RECEIPT DATE: 4-23-15 **ONSITE SEWAGE DISPOSAL SYSTEM** P 555826

PROPERTY ADDRESS: 2791 FLORENCE ROAD, WOODBINE MD 21797

SUBDIVISION: LAYTON KNOLL LOT: 6 TAX ID: 04-596847

SITE PLAN FOR BAT SYSTEM INSTALLATION
LAYTON KNOLL
 LOT 6
 2791 FLORENCE ROAD
 ZONED RC-DEO
 TAX MAP NO.: 7 GRID NO.: 19 PARCEL NO.: 112
 FOURTH ELECTION DISTRICT HOWARD COUNTY, MARYLAND
 SCALE: 1" = 30' DATE: DECEMBER, 2014

**HOUSE LOCATION
DRAWING**

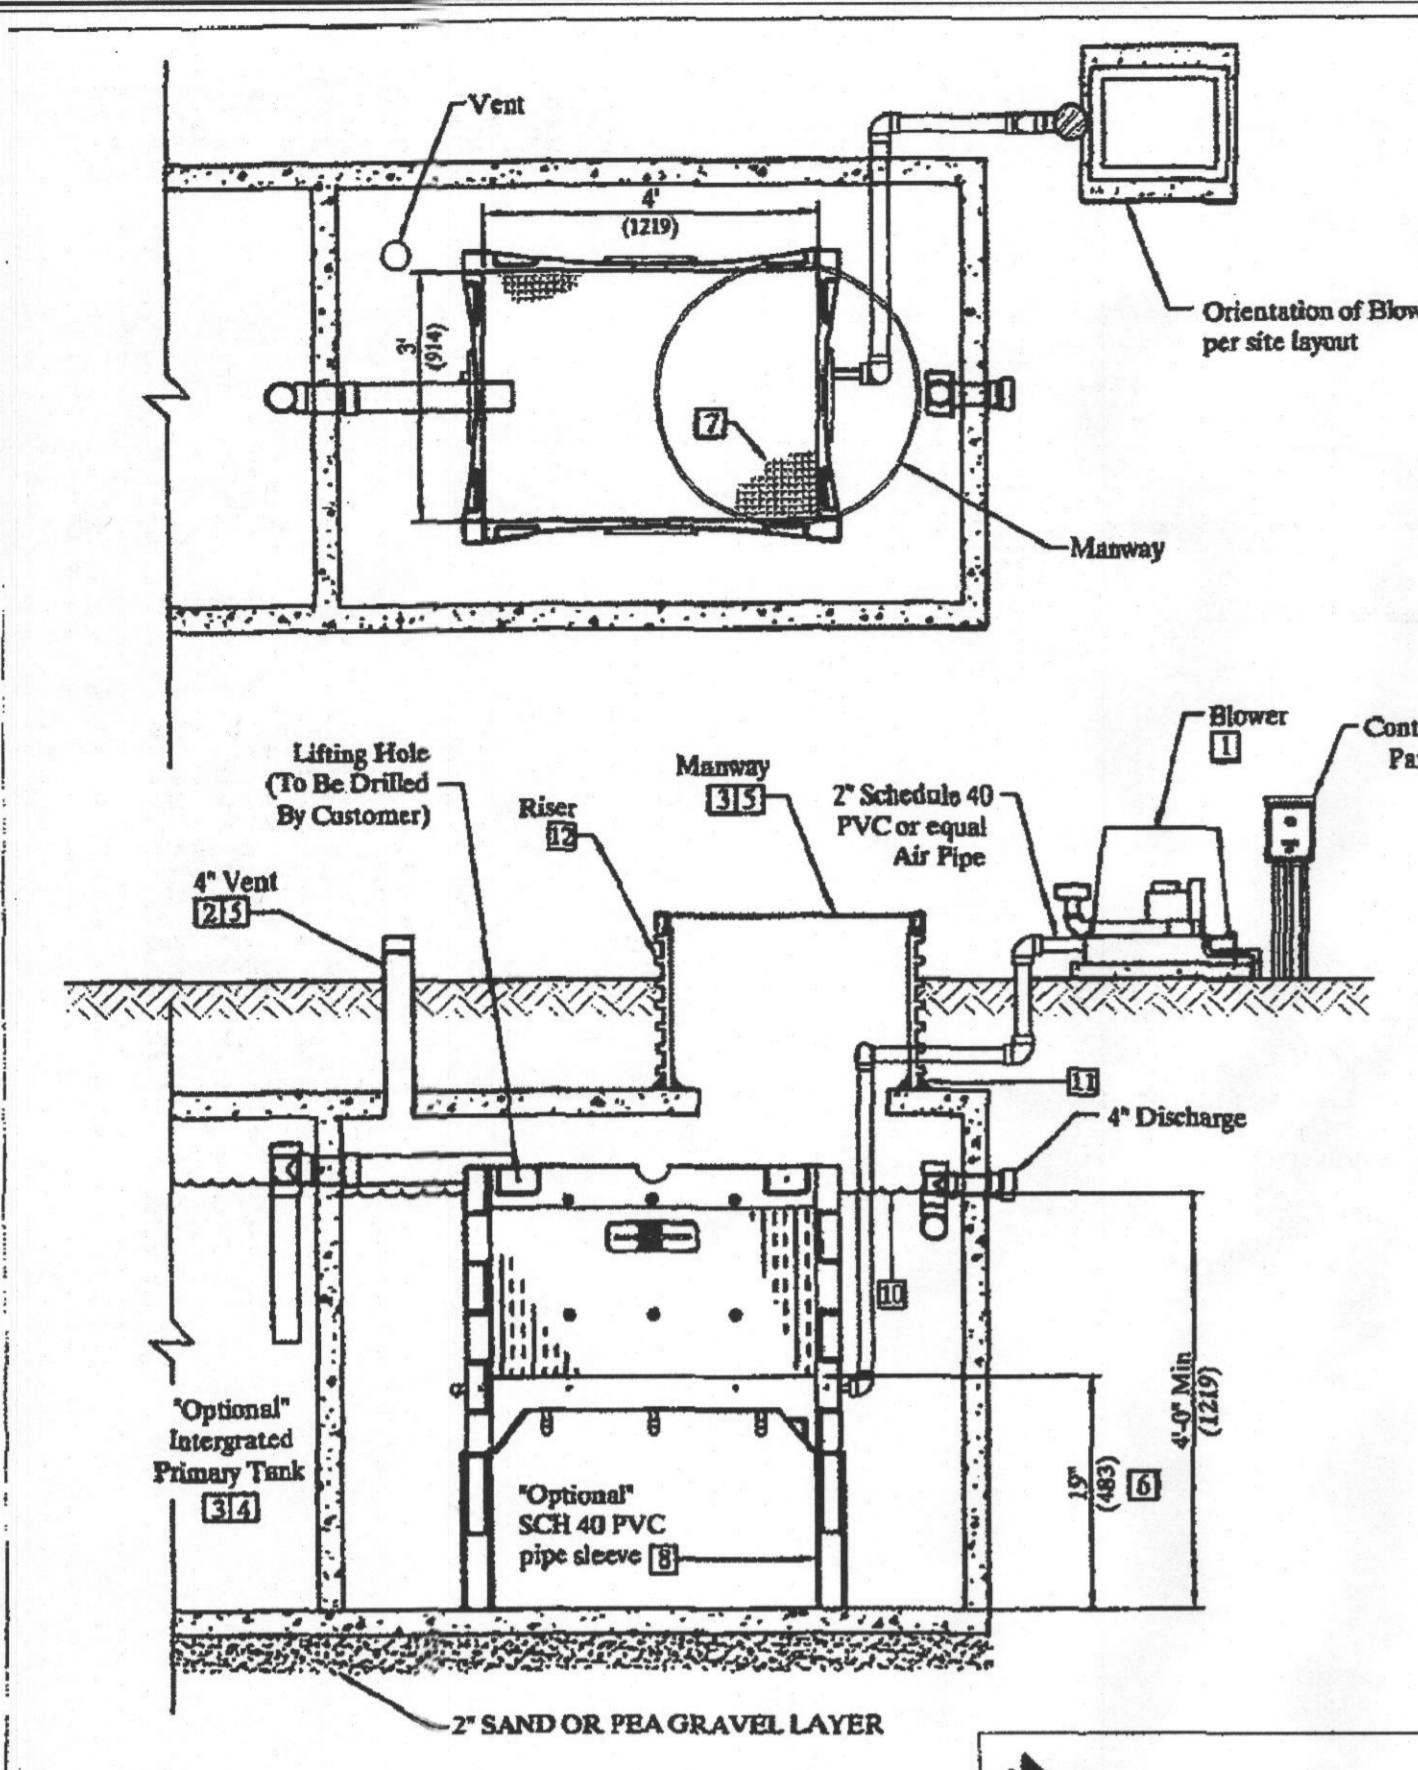
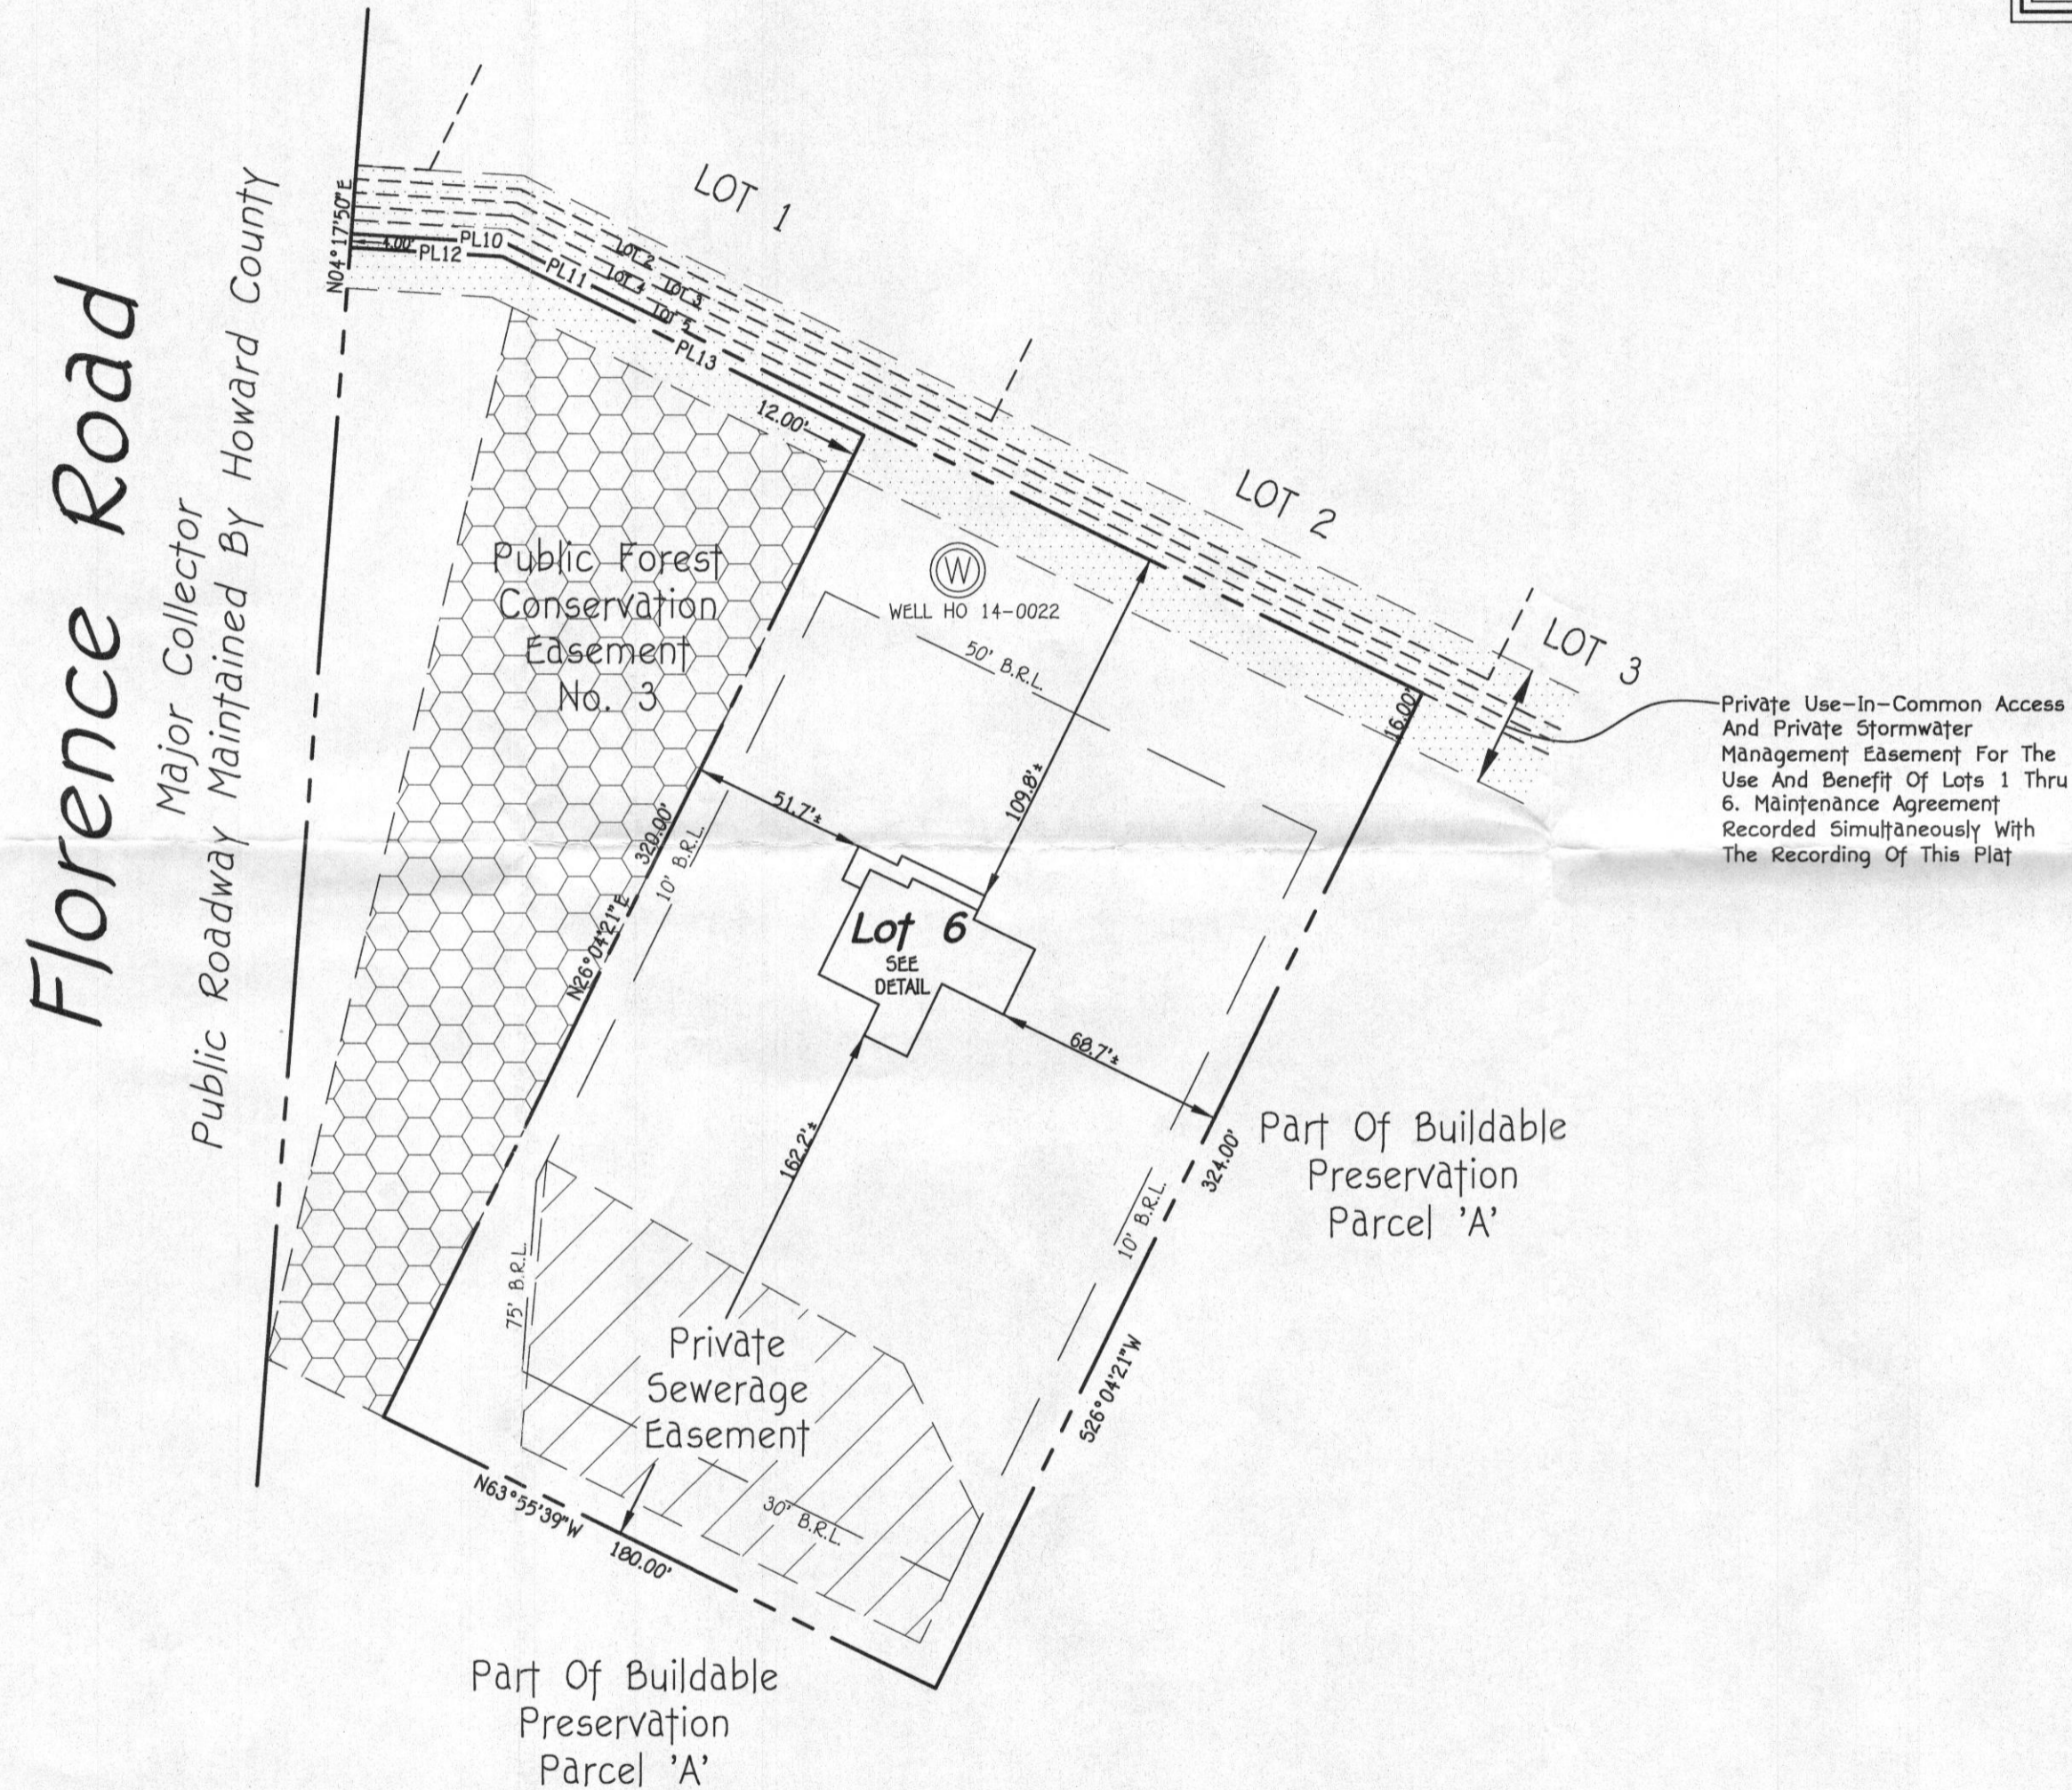
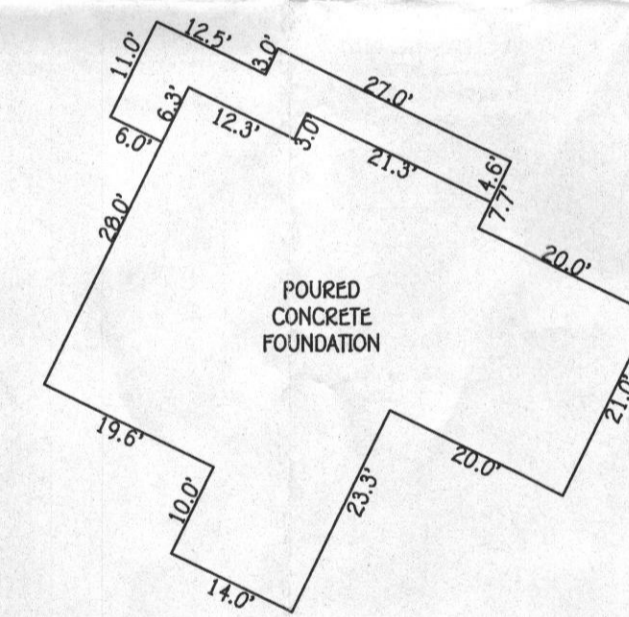
3/10/15.
Informed WTC Builders about ELOPOD moratorium. BAR plan will be revised & submitted for review.
-H.O.

3/10/15-
Well check approved.
-H.O.
